COMBUSTION ENGINEERING, INC.

License SNM-1067
Docket 70-1100
July 3, 1969

Combustion Engineering, Inc., requests that its Source & Special Nuclear Material License #SNM-1067 be amended to allow the use of its fuel bundle shipping container, identified as CE Model 927A, for delivery of the Palisades Fuel Bundles to a carrier for transport.

Application for Licensing of Combustion
Engineering, Inc., Fuel Bundle
Shipping Container
Model: CE 927A

Figure
1

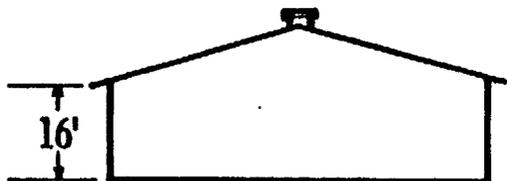
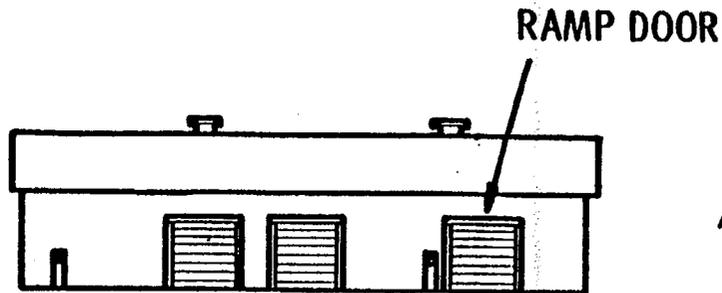
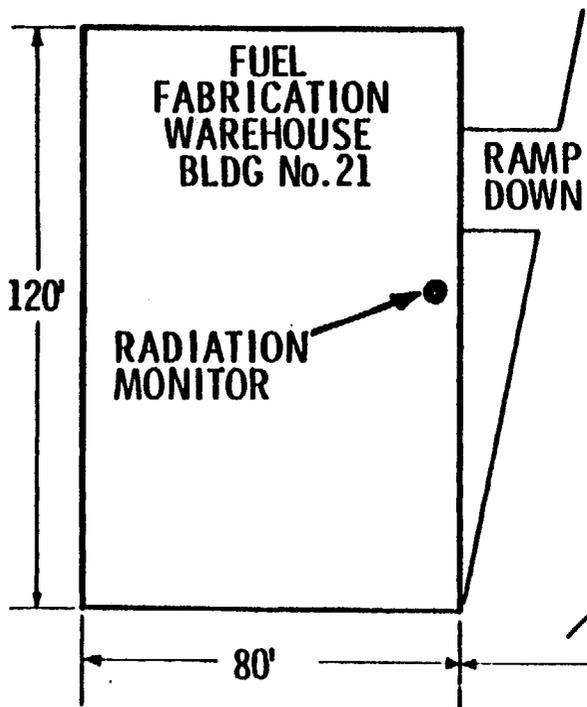
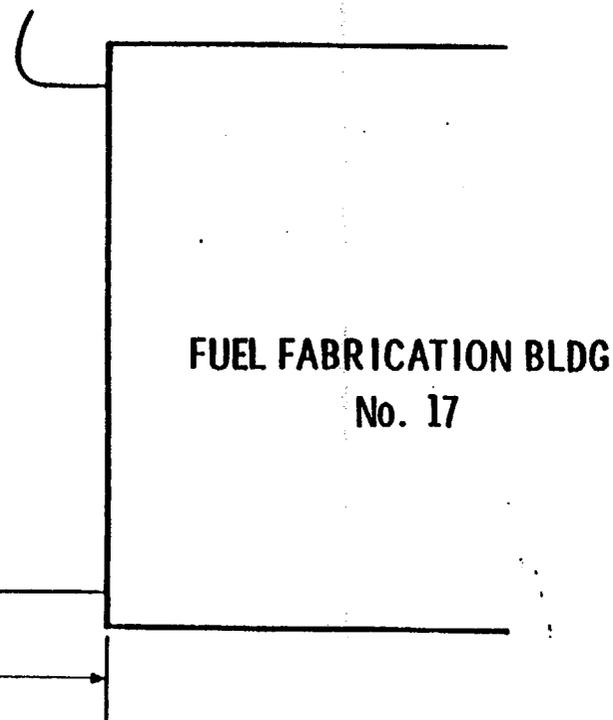
2. Exhibit O - Figure 1 - Page 5 - Revised June 12, 1969

This page indicates that Radiation Monitor - Bldg. #21 is located on the inner East Wall rather than the inner West Wall as stated in the original application.
